IMSAI ECO 77-0039

Affected products: CP-A Rev-4

Summary

IMSAI SYSTEM
 CP-A REV. 4
 COMPONENT SIDE
 ECO 77-0098

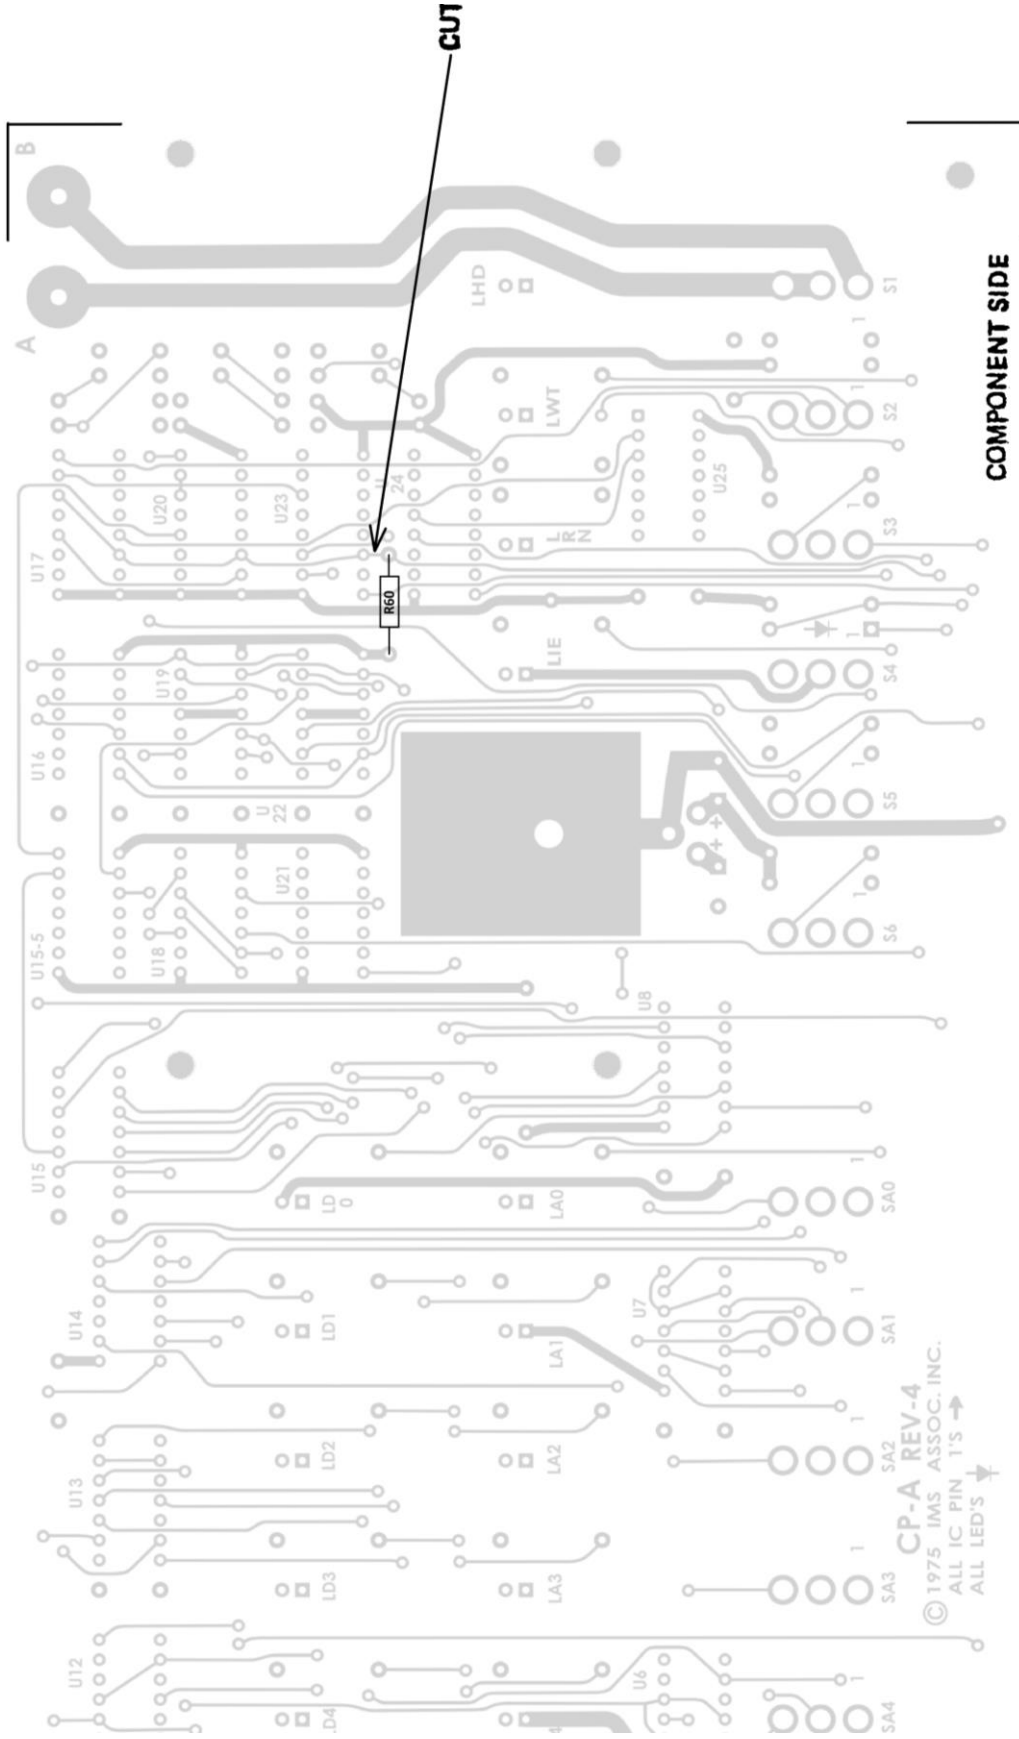
1. On the component side:
 - a. Cut the trace between U23 pin 11 and the load side of R60.
2. On the solder side:
 - a. Cut the trace between U17 pin 2 and via.
 - b. Cut the trace between U20 pin 11 and I19 pin 8.
 - c. Install a jumper between U20 pin 11 and U22 pin 6.
 - d. Install a jumper between U19 pin 8 and the load side of R60.
 - e. Install a jumper between U17 pin 2 and U17 pin 3.
3. Refer to the following diagrams for clarification.

SOLDER BRIDGE (MAY HAVE BEEN PREVIOUSLY IMPLEMENTED)

IMSAI SYSTEM
CP-A REV. 4
CIRCUIT SIDE
ECO 77-0098

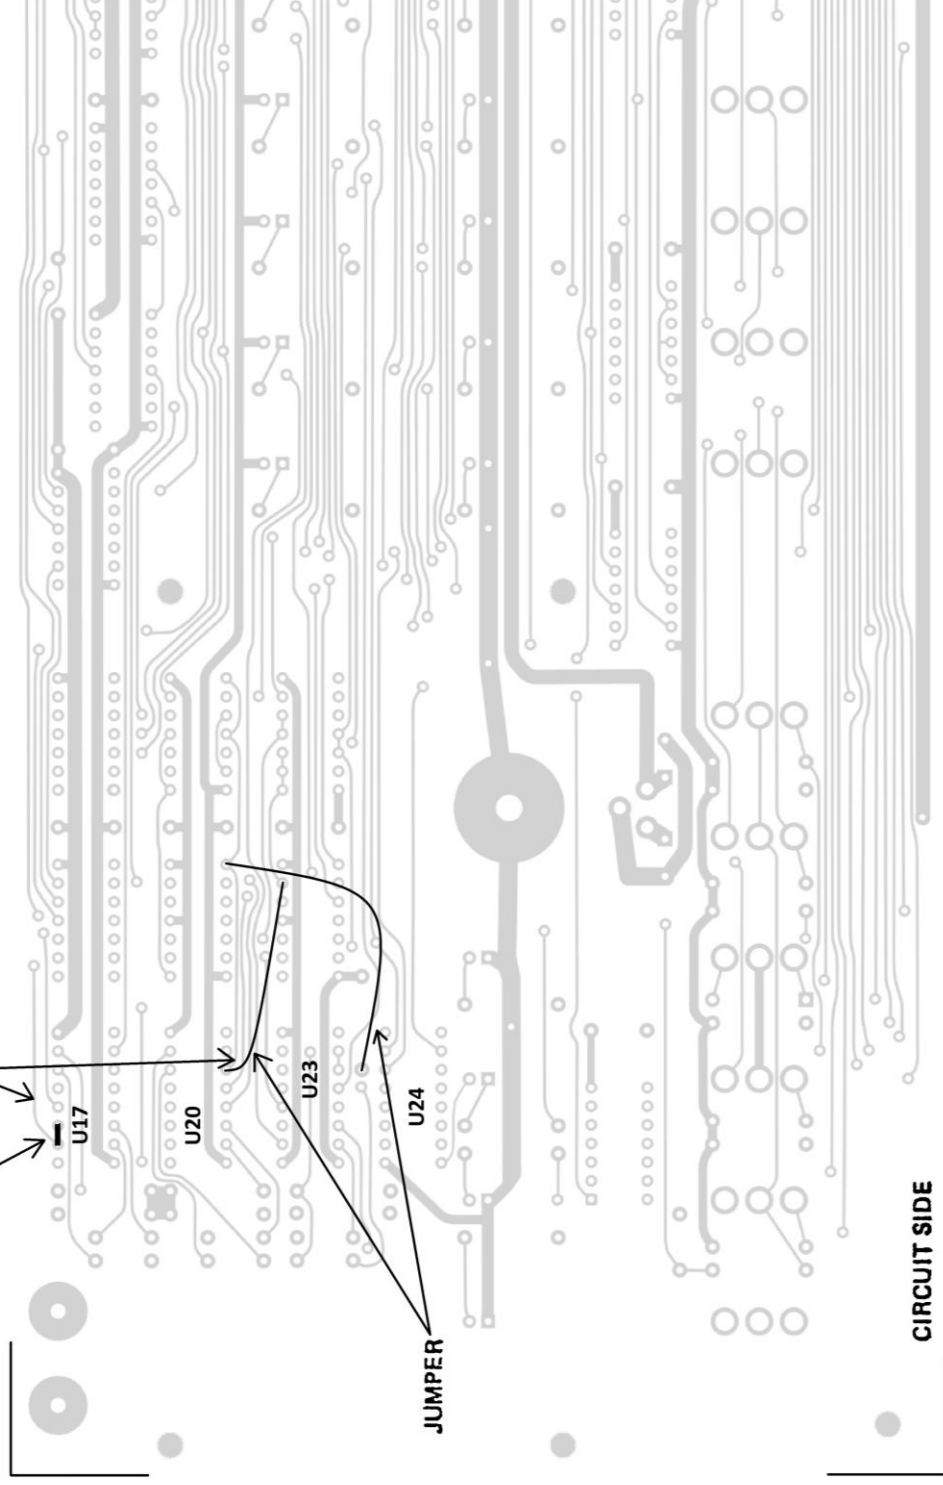
CUT
